Title of Change:	Lead Frame Vendor and Design change for PDIP7 Products Assembled in Advanced Semiconductor Engineering (ASE) Kunshan, China.
Proposed first ship date:	13 May 2017 or earlier after customer approval
Contact information:	Contact your local ON Semiconductor Sales Office or <marty.paul@onsemi.com>
Samples:	Contact your local ON Semiconductor Sales Office
Additional Reliability Data:	Contact your local ON Semiconductor Sales Office or <andy.esteva@onsemi.com>
Type of notification:	This is a Final Product/Process Change Notification (FPCN) sent to customers. FPCNs are issued 90 days prior to implementation of the change. ON Semiconductor will consider this change accepted, unless an inquiry is made in writing within 30 days of delivery of this notice. To do so, contact <PCN.Support@onsemi.com>.
Change Part Identification:	Affected products will be identified with date code 1720 or newer. After DC 1720, customers will receive products assembled with either lead frame vendor.

Description and Purpose:

Figure 1 - External End View

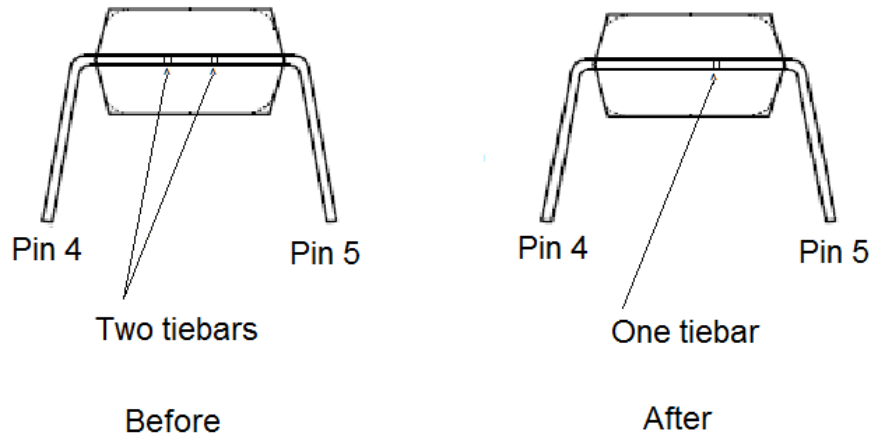
The form of the Lead Frame has also been modified to improve creepage distance between tie bars, see figure 1. One tie bar has been removed.

Material to be changed	Before Change	After Change
	Description	Description
Leadframe	PDIP7 Lead frame with 4 tie bars	PDIP7 Lead frame with 3 tie bars and new vendor
